Eagle Ranch

THE HIGHLANDS DESIGN GUIDELINES RIDGELINE ADDENDUM

February 2022

Ridgeline Addendum
Highlands Design Guidelines
Eagle Ranch Planned Unit Development
Eagle, Colorado
~~October 2020~~ **February 2022**

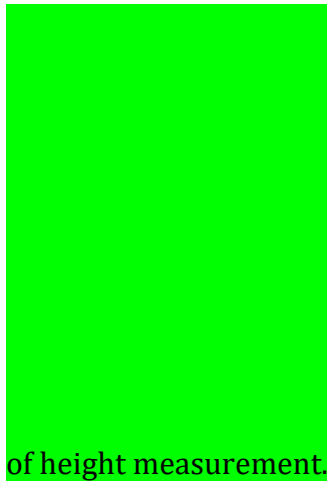
- ~~a. All portions of structures must be contained below a plane elevated 30 feet above the more restrictive of the existing or proposed grade at the perimeter of the structure. This plane shall be graphically represented on all architectural elevations in the~~

Preliminary and Final Plan sets to show that the entirety of the building is within its permitted height. Building height means the distance measured vertically from the existing grade or finished grade (whichever is more restrictive) at any given point outside the building to the top of a sloping roof. Within a building footprint, height shall be measured vertically from any point on a sloping roof to the existing grade or finished grade directly below said point. Chimneys, shrouds, and flues/vents, may protrude no more than 3'-0" above the height limit. Sketch below shows the graphic representation

of height measurement.
